# Access Compliance Report

## Public Rights-of-Way

### (Curb Ramps)

Intersection ID: 46026	Main Street: BITTINGER_CT	Cross Street: PAULINE_LN	Location: NE
ADA ID: AB0F51B0D8E7	Ramp Type: PerpDiag	Initial Pass/Fail: Fail	Overall Compliance: No
Severity Score: 22.5			
Codes/Mitigation Info/Possible Solution		Field Measurements/Component Compliance

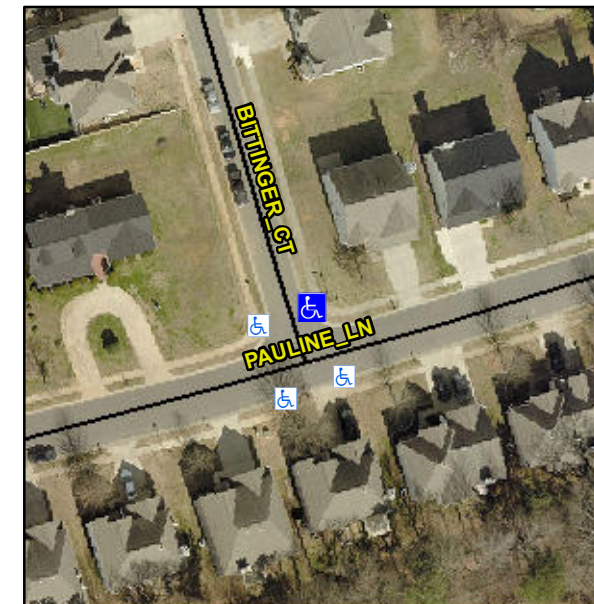
**Not Found, R304.5.1, R304.2.2, R304.5.3**

Compliance	Description	Data	Compliance	Description	Data
N/A	Ramp Length (in)	48.0	No	Ramp Slope (%)	8.6
No	Ramp Width (in)	47.5	No	Ramp XSlope (%)	3.8
N/A	Flare Type LT	N/A	N/A	Flare Type RT	N/A
N/A	Flare Slope LT (%)	N/A	N/A	Flare Slope RT (%)	N/A
N/A	Flare Traversable LT?	N/A	N/A	Flare Traversable RT?	N/A
N/A	Landing Length (in)	N/A	N/A	DWS Provided?	N/A
N/A	Landing Width (in)	N/A	N/A	DWS Contrast?	N/A
N/A	Landing Slope (%)	N/A	N/A	DWS Length (in)	N/A
N/A	Landing X Slope (%)	N/A	N/A	DWS Full Width?	N/A
N/A	Landing Curb? (Y/N)	N/A	N/A	DWS Offset (in)	N/A
N/A	Shared Landing?	N/A			
N/A	Gutter Ponding?	N/A	N/A	Gutter Slope (%)	N/A
N/A	Gutter Lip Ht (in)	N/A	N/A	Gutter X Slope (%)	N/A
N/A	Painted X Walk1?	No	N/A	Painted X Walk2?	No
	X Walk 1 Direction	To W		X Walk 2 Direction	To S
N/A	X Walk 1 Width (in)	N/A	N/A	X Walk 2 Width (in)	N/A
	X Walk 1 Slope (%)	5.4		X Walk 2 Slope (%)	1.7
	X Walk 1 X Slope (%)	1.6		X Walk 2 X Slope (%)	6.6

**Remove & Replace Curb Ramp With Two New Directional Ramps or Equivalent.**
